Access Compliance Report Public Rights-of-Way (Curb Ramps)

Intersection ID: 21238 Main Street: CAROSAN_LN Cross Street: SARDIS_LN Location: NW Ramp Type: Directional1 **Overall Compliance: No Severity Score:** ADA ID: 2B8B7A3C93D0 Initial Pass/Fail: Fail 12.5

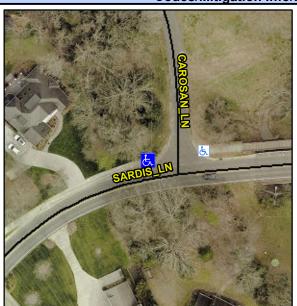
Field Measurements/Component Compliance							
Comp	liance Description	Data	Comp	liance Description	Data		
N/A	Ramp Length (in)	104.0	N/A	Grade Break?	N/A		
Yes	Ramp Width (in)	76.0	N/A	Grade Break Slope (%)	0.0		
No	Ramp Slope (%)	10.6	N/A	Grade Break XSlope (%)	0.0		
Yes	Ramp XSlope (%)	1.3					
N/A	Flare Type LT	N/A	N/A	Flare Type RT	N/A		
N/A	Flare Slope LT (%)	N/A	N/A	Flare Slope RT (%)	0.0		
N/A	Flare Traversable LT?	N/A	N/A	Flare Traversable RT?	N/A		
N/A	Landing Length (in)	0.0	N/A	DWS Provided?	N/A		
N/A	Landing Width (in)	0.0	N/A	DWS Contrast?	N/A		
N/A	Landing Slope (%)	0.0	N/A	DWS Length (in)	N/A		
N/A	Landing X Slope (%)	0.0	N/A	DWS Full Width?	N/A		
N/A	Landing Curb? (Y/N)	N/A	N/A	DWS Offset LT (in)	N/A		
N/A	Shared Landing?	N/A	N/A	DWS Offset RT (in)	N/A		
N/A	Gutter Ponding?	0.0	N/A	Gutter Slope (%)	N/A		
N/A	Gutter Lip Ht (in)	0.0	N/A	Gutter X Slope (%)	N/A		
N/A	Painted X Walk1?	No		Road Slope (%)	1.6

Possible Solutions:	
Remove & Replace Entire Ramp.	
Surveyor Notes:	
N/A	
PROW/ADA:	
R304.2.2	
•
